SERVICE BULLETIN SB FSG2T-1.06

TYPE DESIGNATION FSG 2T VHF/AM Airband Transceiver – Part number F10350

REASON Possible degradation of operational availability could create disruption of VHF communication due to internal capacitor misplacement. The capacitor could be destroyed and could be separated with possible generation of smoke.

Fig. 1: TX/RX Module with misplaced Capacitor C2038

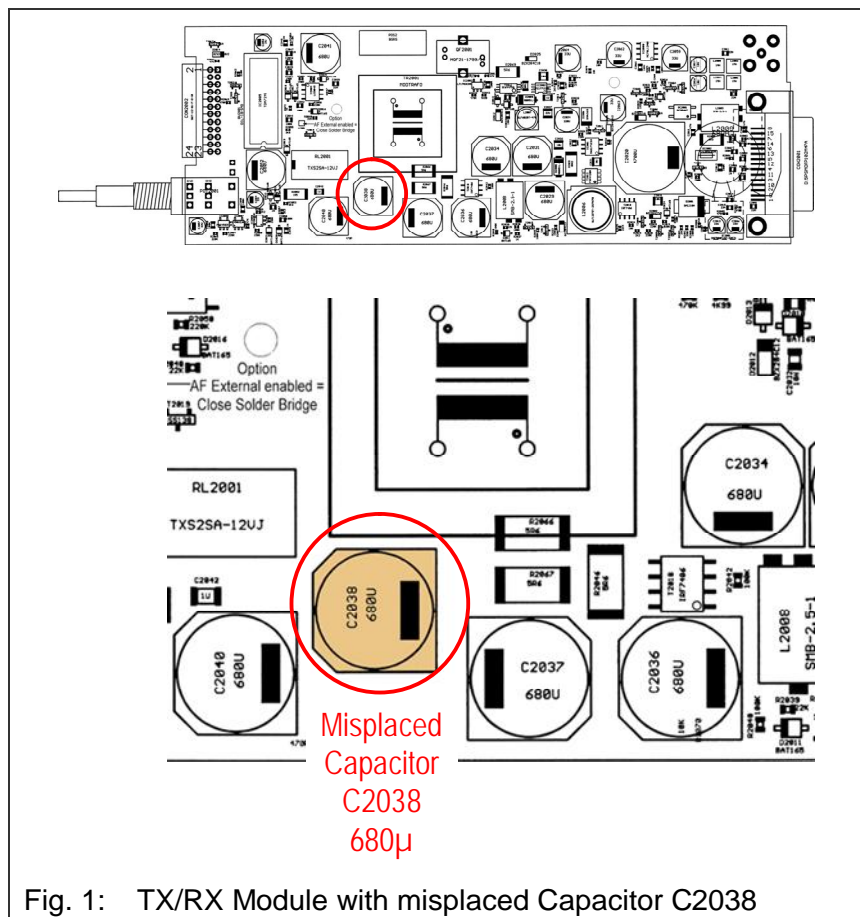
DESCRIPTION Replace the misplaced capacitor by a new capacitor placed as shown in the attachment. To have access to the capacitor it is necessary to open the unit and to separate the TX/RX Module from the Chassis. Remove the adhesive fixing and replace the SMD capacitor.

Locate the misplaced capacitor C2038 (680 μ) on the TX/RX Module.

Fig. 3: Position of Mod-Index Label

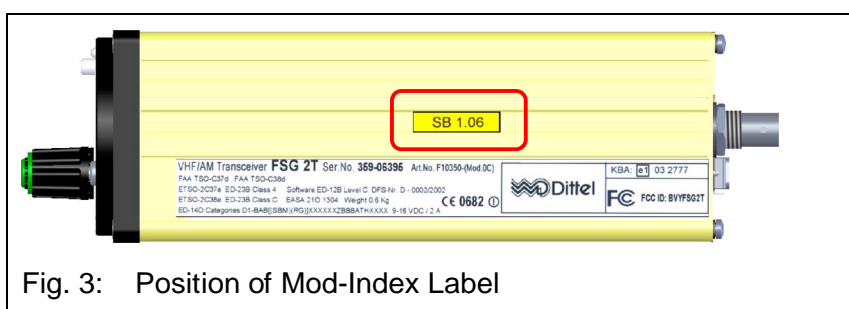
After meeting the required minimum performance values mark the transceiver FSG 2T with the supplied Mod-Index label
